Letter of Transmittal

Date: 7-16-2026
Petition Map: 26-54

QUEENS BAR OUTDOOR SEATING

BULLETIN 3 DATED JUNE 30, 2026

REQUEST ENCROACHMENT
INTO FARMER ST. BETWEEN
GRAND RIVER AVE. AND JOHN R ST.
AT 1401 FARMER ST.

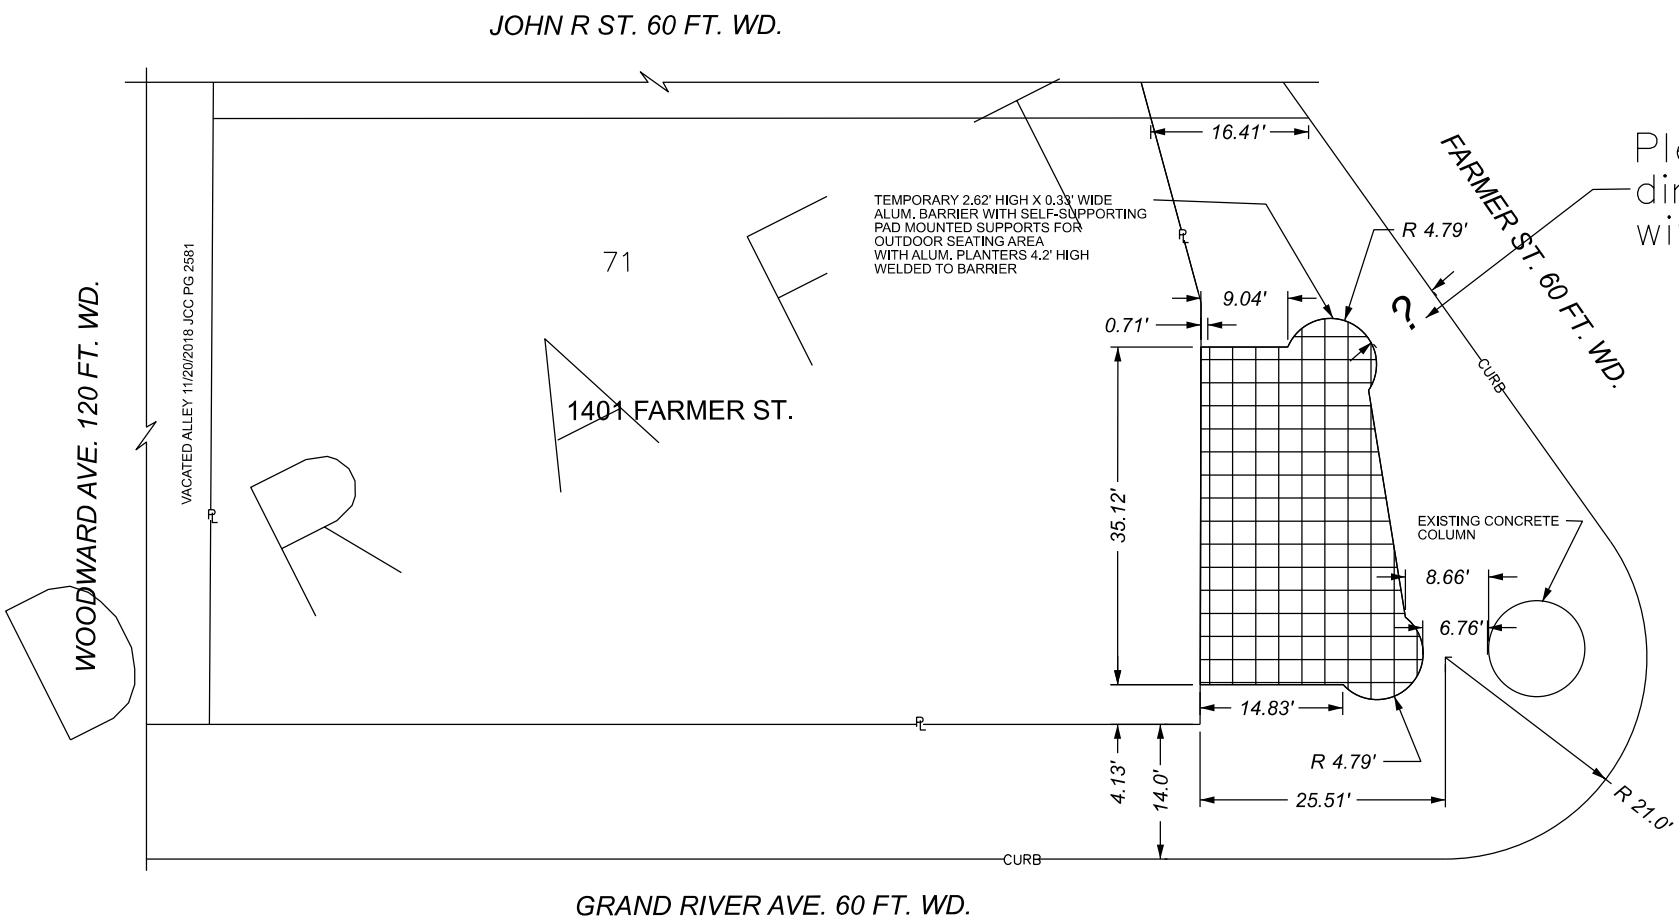
Please provide the dimension marked with "?"

TS1.1

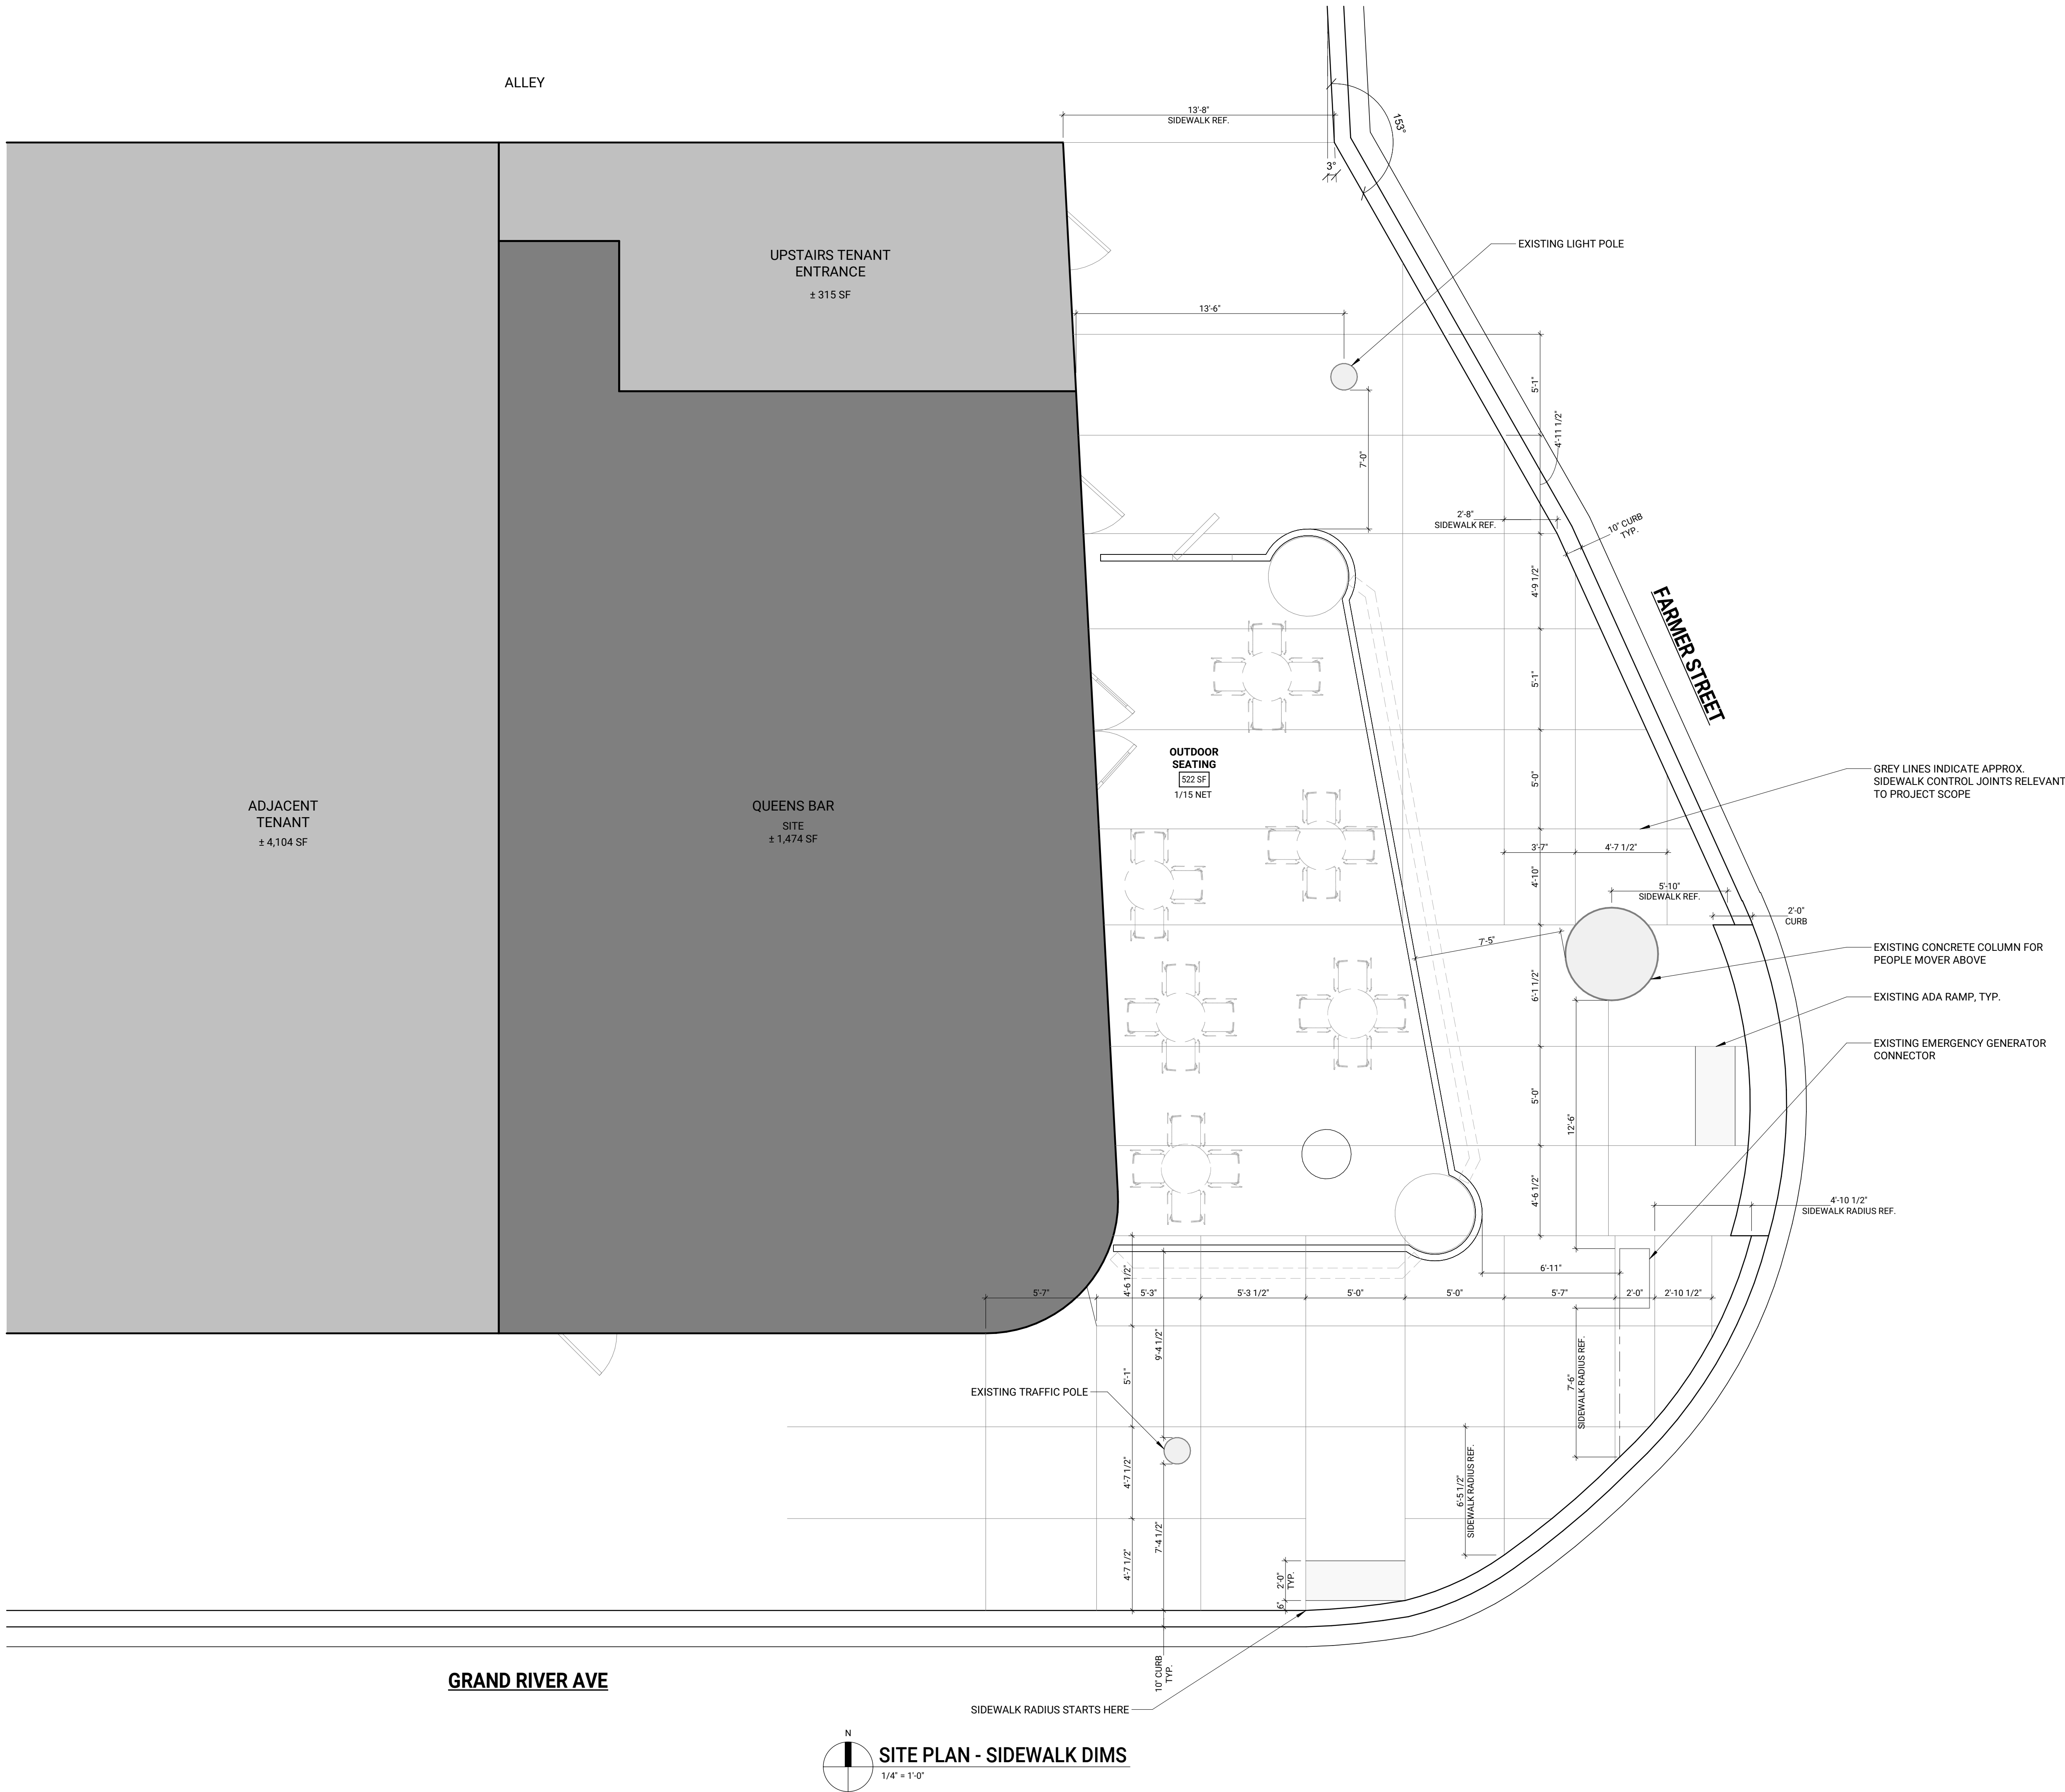
1. Updated Occupancy / Egress Width / Exit Capacity chart.
2. Updated annotations on Architectural Site Plan.
3. Updated dimensions on Architectural Site Plan.
4. Updated site conditions on Architectural Site Plan.
